RAI Volume 2, Chapter 2.1.1.3, Third Set, Number 6:

RAI Volume 2, Chapter 2.1.1.3, Third Set, Number 8:

RAI Volume 2, Chapter 2.1.1.3, Third Set, Number 15:

Figure 1. Industrial, Commercial, and Military Facilities and Activities in Proximity to Yucca Mountain (SAR Figure 1.1-6)

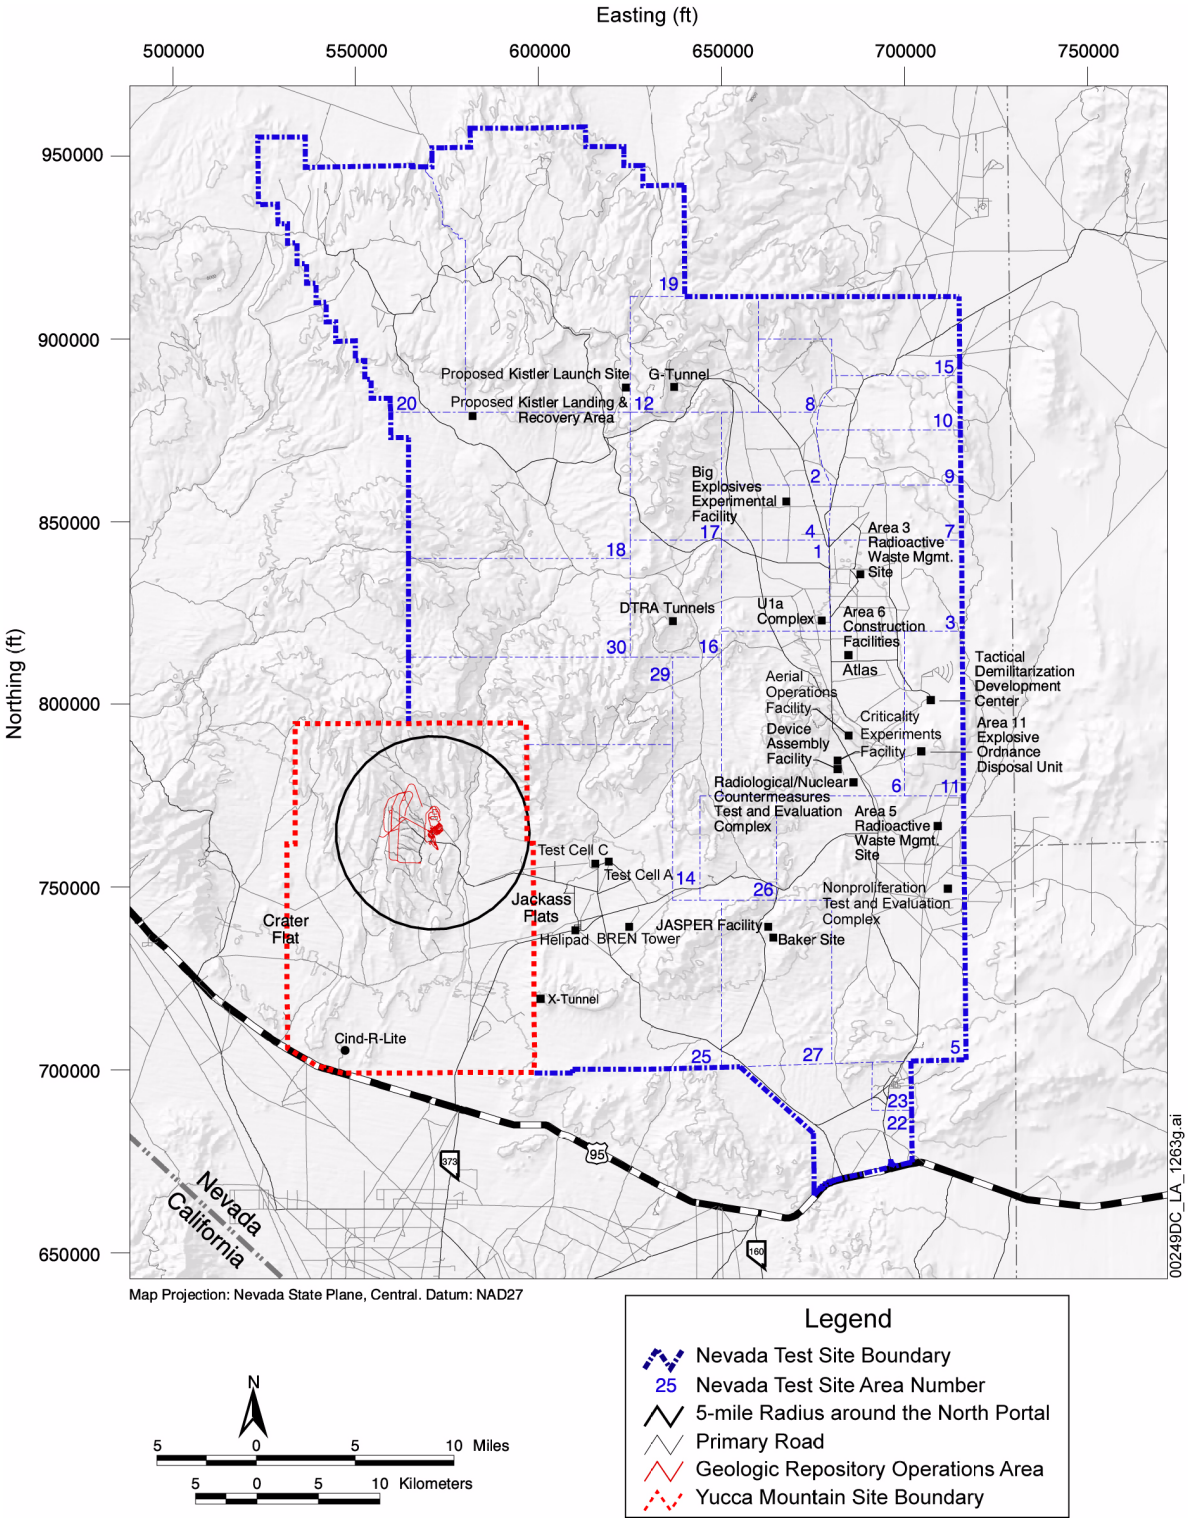
Provide the technical bases to demonstrate that potential hazards from nearby facilities, as documented in SAR Section 1.6.3.4.8 Nearby Industrial or Military Facility Accidents, were properly screened out. Also, provide information to demonstrate that the analyses are supported by current, up-to-date information. Specific examples include, but are not limited to:

- No rationale has been provided for the conclusion that ground motions at Yucca Mountain repository from nuclear tests at the repository would be bounded by moderate to large earthquakes in the region or the activities associated with the program to defeat military missions protected in tunnels and hardened deeply buried facilities would not affect the repository.

- No justification is provided for why an accidental detonation of the "maximum high explosive device" at the Device Assembly Facility or the tests performed at U-1a Complex/Lyner Complex or the tests with high explosives performed at the Big Explosives Experimental Facility would not initiate an event sequence at the repository.

- No basis is provided for the conclusion that the probability of an explosion in Area 27 complex is one in 10,000,000 per year.
- No justification is provided for why Storage and Disposition of Weapons-Usable Fissile Materials would not affect the repository.

- No basis is provided for the conclusion that the worst sequence from an accident at the Joint Actinide Shock Physics Experimental Research would be minor local contamination.

- Information provided for the Next Generation Radiographic and Magnetic Flux Compression Generation Facilities relies on a conceptual description in an environmental impact statement published in 1996.

SAR Figure 1.1-6 (reproduced as Figure 1) shows the location of the repository site. A five-mile radius has been drawn around the surface GROA centered on the repository North Portal. This

figure illustrates that the activities discussed in this RAI are substantially outside of the five-mile radius and are within the area of the Nevada test Site (NTS) that is East and North of the site, as described in SAR Section 1.1.1.
